REMARKS

In this amendment, claims 23-30 are amended to more particularly point out the various embodiments of the invention. No new matter has been added as the amended subject matter is fully supported in the application as filed, and particularly in Fig. 2, as well as corresponding text of the Detailed Description.

COPY OF FIG. 4
 FOR DISCUSSION ONLY

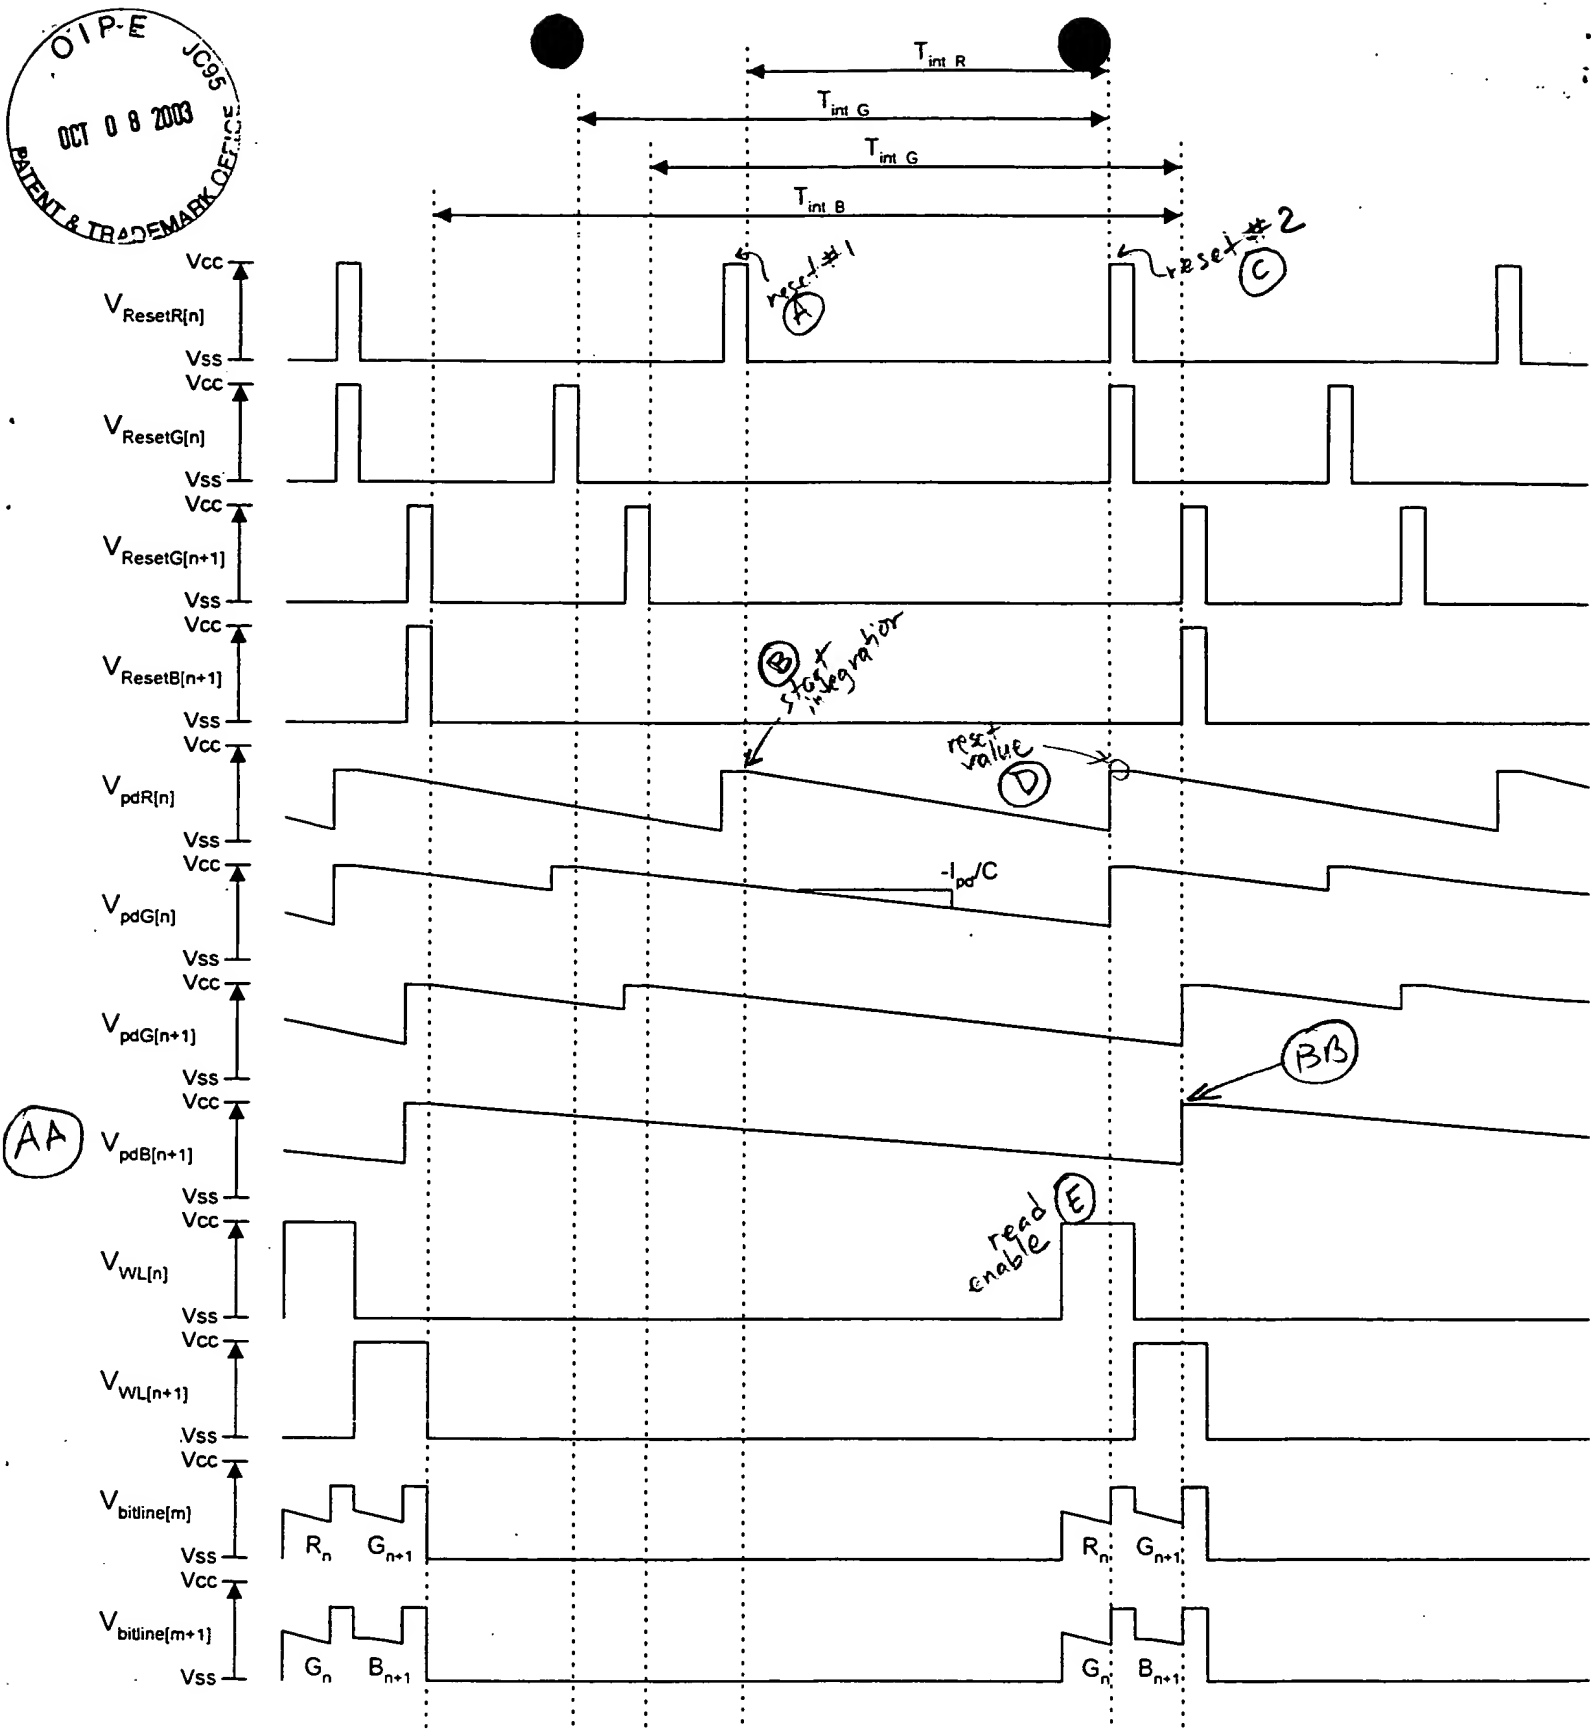
The Examiner also objected to Fig. 4 as being apparently confusing. According to the Examiner, the timing for the red and green pixels is shown at *time* n and that for the blue pixels at *time* n+1. However, Applicants respectfully point out that the index n and n+1 does not refer to time but rather to different *rows* of the sensor array.

Finally, with respect to the Examiner's question as to how correlated double sampling can be performed for the blue pixel, using only one reset bit, Applicants provide the following explanation, which compares red and blue pixels. Note that in the copy of Fig. 4 attached to this amendment, the operation of red pixels is depicted by the sequence A-E, where operation begins with the first reset occurring as indicated by A. This reset causes the voltage for red pixels to jump to their reset value, and the start of integration occurs when the reset voltage drops, as indicated by B. Near the end of integration, a second reset is applied, as indicated at C. This in turn, causes the voltage of the red pixel to jump to its reset value as indicated at D. Note, however, that the

actual read-out of the voltage at the end of the integration time is enabled by the wordline signal, as indicated by the pulse at E. Thus, during the read enable pulse E, two values are read for the red pixel, namely the end-of-integration value, followed by the reset value. Similarly, two values are read for the blue pixel, enabled by the wordline signal at row (n+1).
